Preliminary Plan, 120150090, Mount Prospect

Staff Report Date: 2/5/16

Request to subdivide Parcel 570 (12230 McCrossin Lane) to create three lots for 3 detached single-family dwellings; 9.48 acres; RE-2 zone; Located at the terminus of McCrossin Lane, 1,800 feet southeast of Travilah Road in Potomac, MD; 2002 Potomac Subregion Master Plan.

Figure 3 - Proposed Preliminary Plan

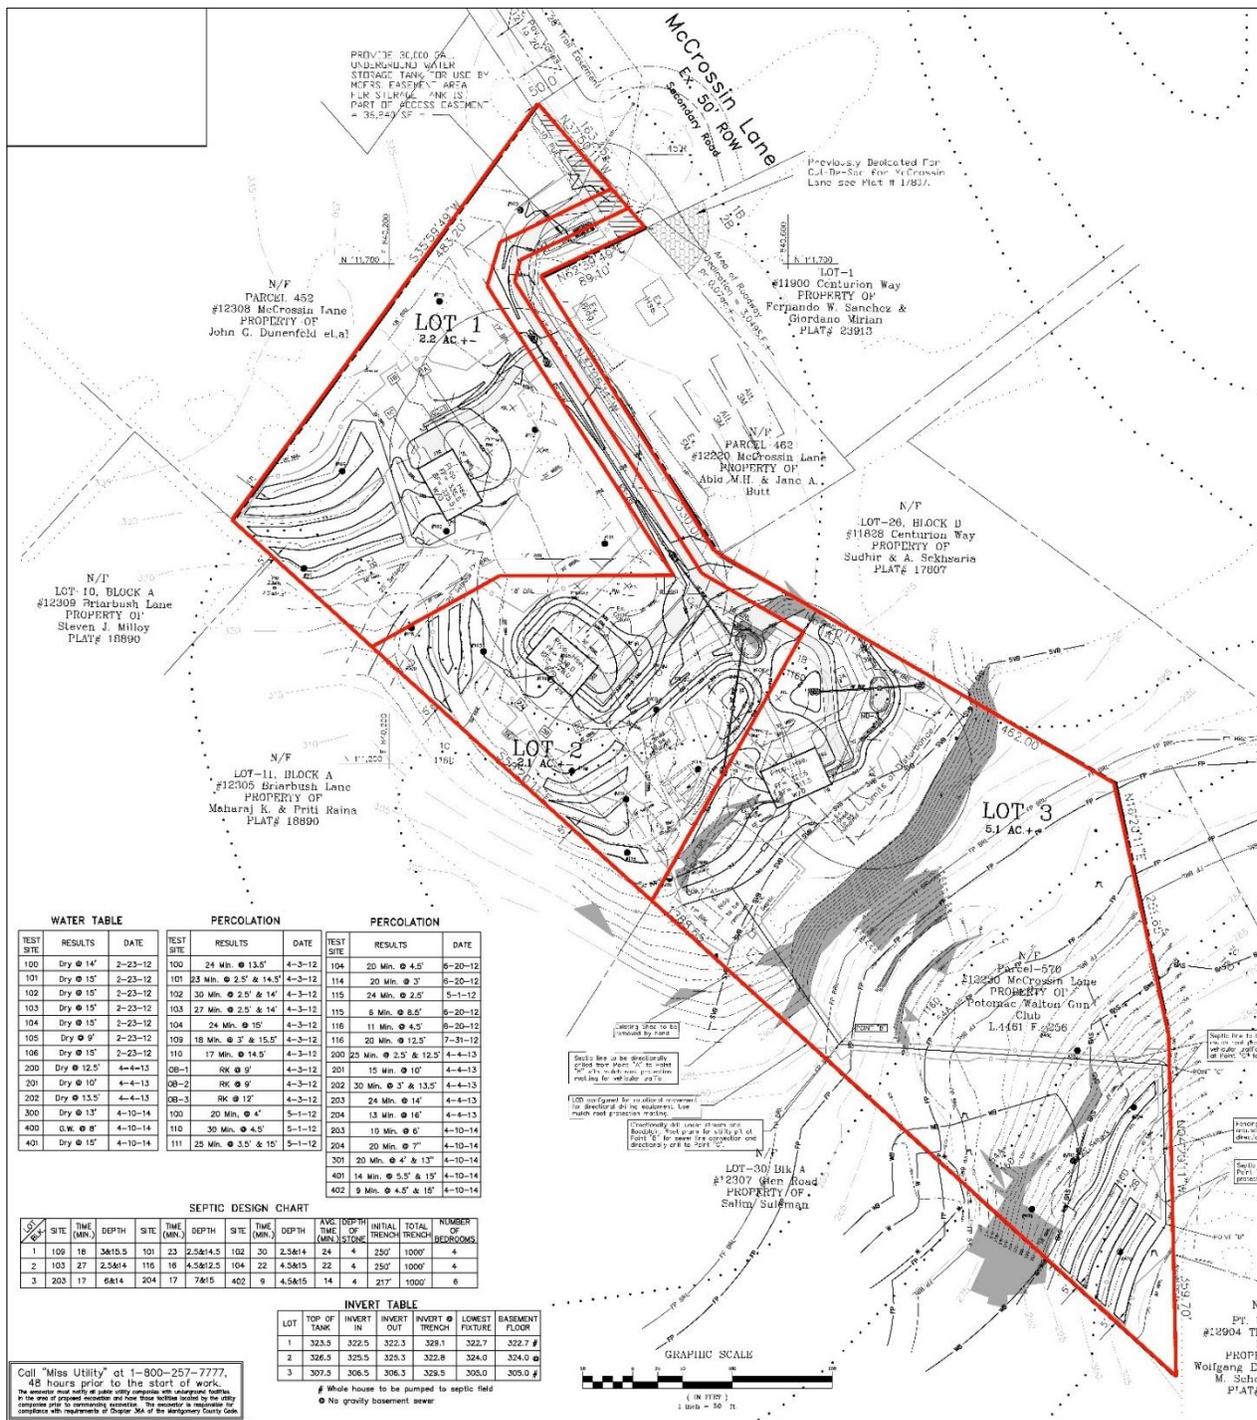
- a. The stormwater management concept approval letter
 - b. The Preliminary Plan Resolution
3. The Certified Preliminary Plan must reference McCrossin Lane as a tertiary road, not a secondary road.

4. The Applicant must dedicate and show on the record plat a dedication of 25-feet of right-of-way from the centerline of McCrossin Lane as shown on the Preliminary Plan.

5. The Applicant must use directional boring to install the septic line for Lot 3 as shown on the Preliminary Plan.
6. The Applicant must comply with the conditions of approval for the Preliminary Forest Conservation Plan no. 120150090, approved as part of this Preliminary Plan, including the following:

Figure 3 - Stream Valley Buffer Impact

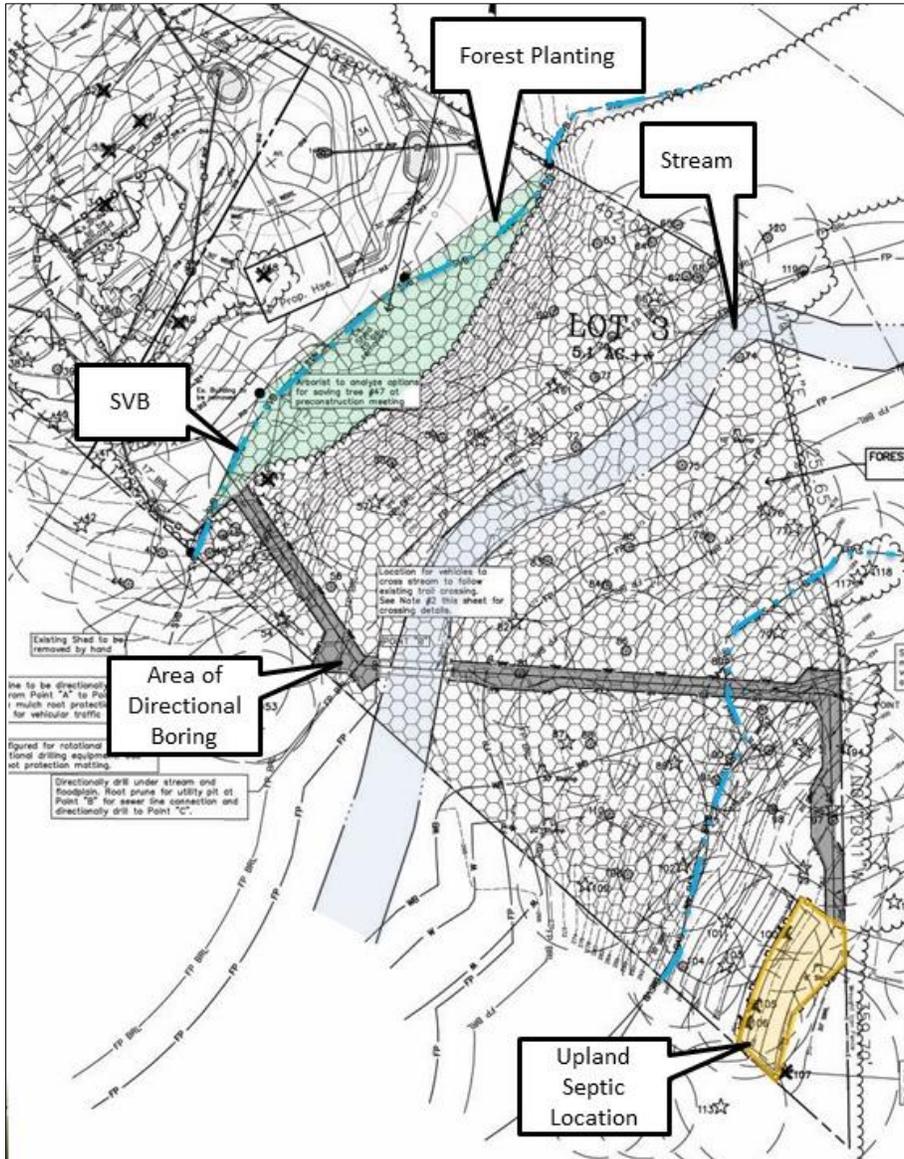
The proposed septic area for proposed Lot 3 is located in the southeast corner of the Property. This portion of the Property is forested but outside the SVB. However, the rear of Lot 3 and the southeast corner are separated by a perennial stream and its associated SVB. The Applicant worked with Staff to develop a plan that provides access to the isolated southeast corner while providing protection and mitigation for the intervening environmentally sensitive areas. As shown in Figure 3, the Applicant has minimized the limits of disturbance within the SVB, provided directional boring of the proposed septic line, and proposed 0.39 acres of mitigation forest planting within unforested SVB.

The proposed septic line in addition to being directionally bored includes a tree protection plan that includes root pruning, mulch root protection matting, tree protection fencing. Specific notes have been added to the FCP to address the details of maintenance and access of the primary septic field trench.

Additionally, the Applicant will submit a Category I Conservation Easement which reflects the notes and conditions for activities associated with the access and maintenance of the septic filed. Staff believes that the proposed plan is consistent with the Environmental Guidelines and provides protection for the environmentally sensitives areas and additional planting of unforested SVB.

- c. Conservation easement signs and split rail fencing, or Staff approved equivalent, must be installed prior to any land disturbing activity.
 - d. In addition to the requirement for the septic line for Lot 3 to be directionally bored, the Applicant must abide by the specific tree protection plan on the Forest Conservation Plan, including root pruning, mulch root protection matting, and tree protection fencing.

- e. The Applicant must follow the specific notes on the Final Forest Conservation Plan addressing the details of maintenance and access of the primary septic field trench for Lot 3.

Figure 4 – Tree Variance (1 of 2)

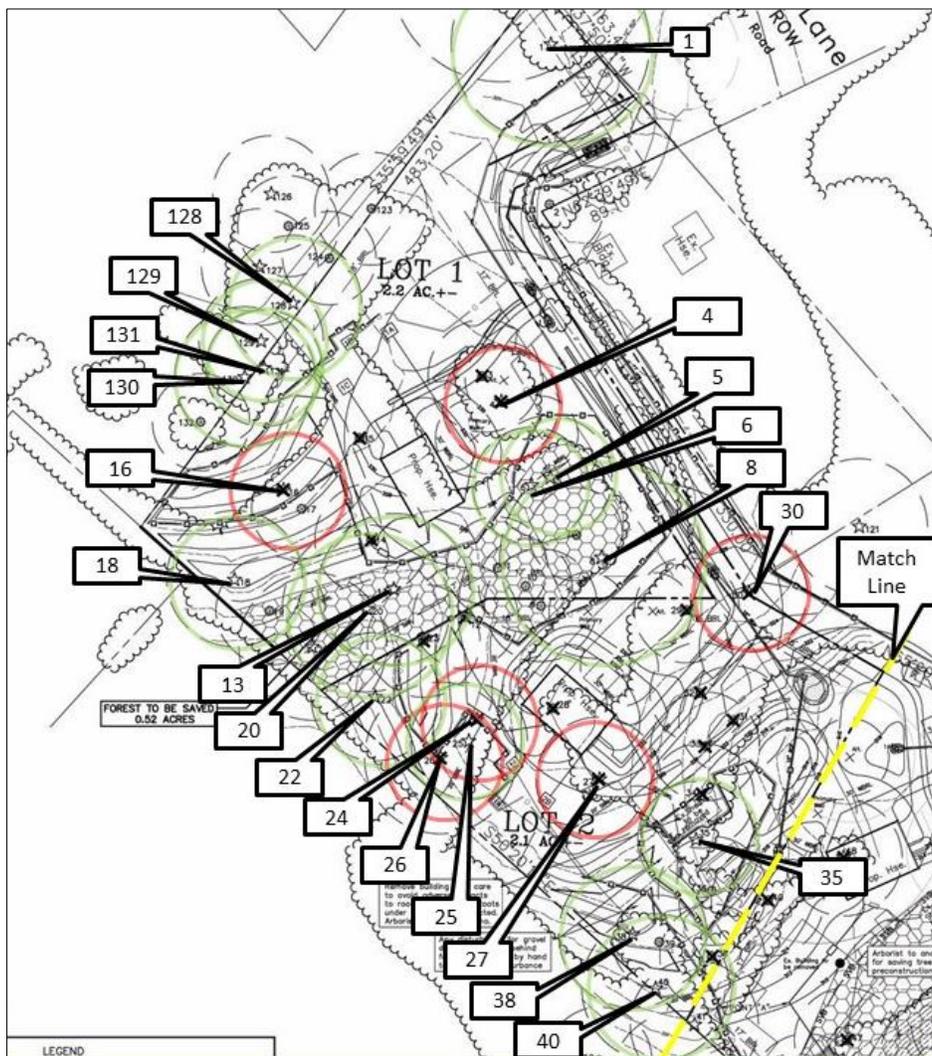
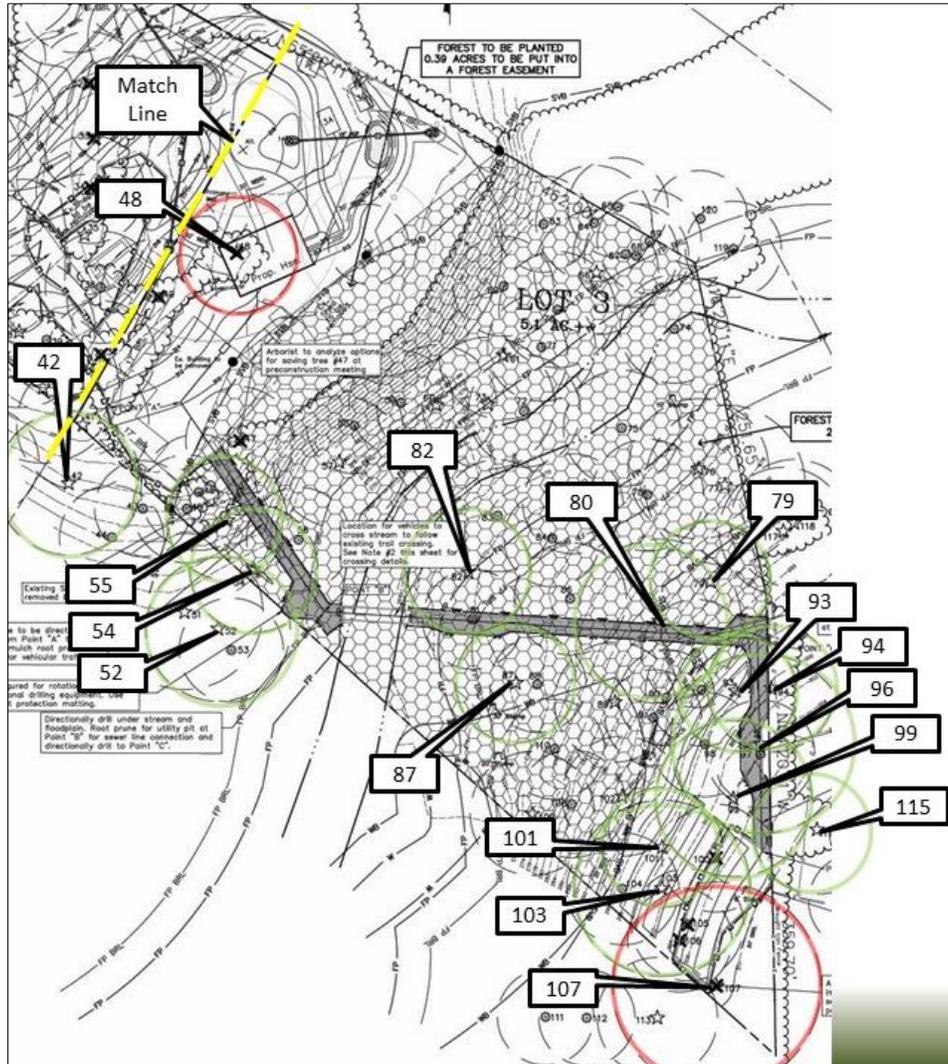
There are eight Protected Trees proposed for removal in this variance request. Four trees are located within areas of forest; the forest conservation worksheet already provides mitigation for forest clearing so no additional mitigation is recommended for these trees.

There are four trees located outside of forested areas and not covered by the mitigation provided from the forest conservation worksheet. Mitigation for the removal of these trees is recommended and Mitigation should be at a rate that approximates the form and function of the trees removed. Therefore, Staff is recommending that replacement occur at a ratio of approximately 1" DBH for every 4" DBH removed, using trees that are a minimum of 3" DBH. This means that for the 122 caliper inches of Protected Trees proposed for removal (outside of forested areas), they will be mitigated by the Applicant by planting 30.5 caliper inches of trees, with a minimum size of 3" DBH on the site.

Staff recommends that the variance be granted with mitigation. The submitted FCP meets all applicable requirements of the Chapter 22A of the County Code (Forest Conservation Law).

- a. The Applicant must plant at least 30.5 caliper inches of native canopy trees on the Subject Property within one year or 2 growing seasons after the development project is complete. The trees must be a minimum of a three-inch caliper size.
